Cross-Ship of Lead-Free Bump in Lead-Free Substrates for Large Die (FFG/FBG/SBG Packages)

XCN19005 (v1.2) December 16, 2019

Product Change Notice

Figure 1: Package Topmark Example

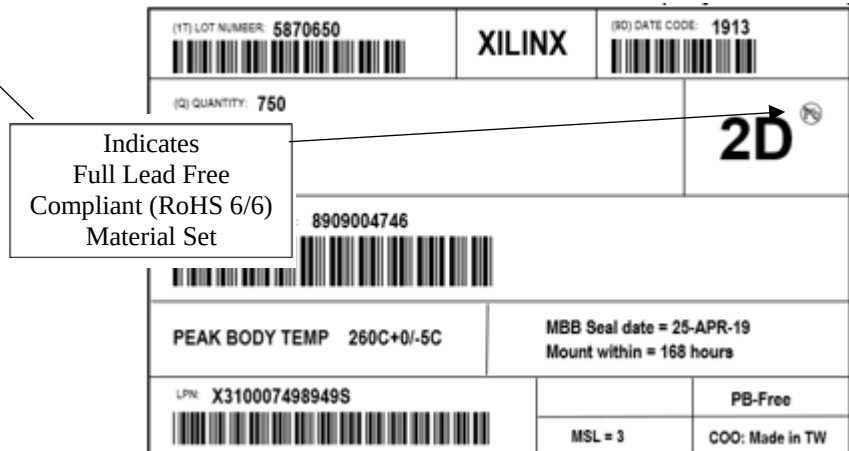
To enable traceability, any products with “G” packages shipped that use the new lead-free material set will be marked with a special Pb-Free character in the upper right corner of the part as shown in [Figure 1](#) below. There will be no mark for the eutectic material set. Marking changes are reflected in the product documents UG195, UG475, UG365 and UG865, available on www.xilinx.com. The RoHS compliant mark will not be on the FF, FB or SB packages with eutectic BGA solder balls.
